**APPLICABLE TO UNIVERSAL (D3) SWIVEL JOINTS FOR
UNDERWING FUELING NOZZLES PART NUMBERS:
47566, 64201N, 64349N ALL SERIAL NUMBERS
PRODUCED TO DATE**

**SB017051147566
May 11, 2007**

UNIVERSAL (D3) SWIVEL JOINT FAILURE REPORTED

SAFETY BULLETIN

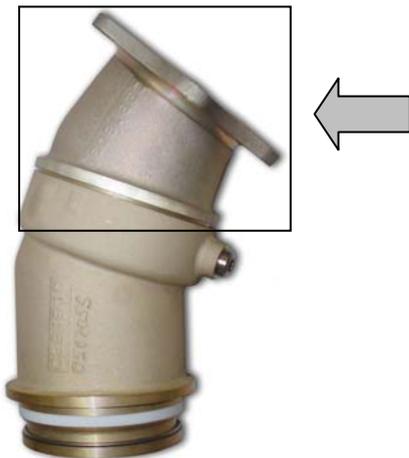
It has come to our attention that one fracture failure has occurred as the result of an accidental dropping of the nozzle assembly after the completion of a refueling. The distance of the drop was less than 3 feet and should not have resulted in a failure of this nature. Inspection of our inventory revealed that a combination of a casting problem and a machining problem provided for an uneven/thin wall thickness on the half that incorporated the MS33786-40 flange. The resulting wall thickness gives us cause for concern and all units presently in service need to be recalled and replaced.

See the picture below showing the half to be replaced.

Carter will replace, free of charge, the flanged half of these Universal Swivel Joints in a kit with the necessary seals and a set of instructions outlining how to remove and replace the suspect part. New parts will be marked "Rev. B", so if your inspection does not show this mark, they need to be replaced.

Prior to the receipt of the replacement parts, we recommend a visual inspection of each Universal Swivel Joint before each use. Any crack or fracture noted in the area where the elbow meets the MS flange is cause for discontinued use. Additionally, operators are warned that rough handling or dropping of the nozzle and/or Universal Swivel Joint may lead to damage as reported above.
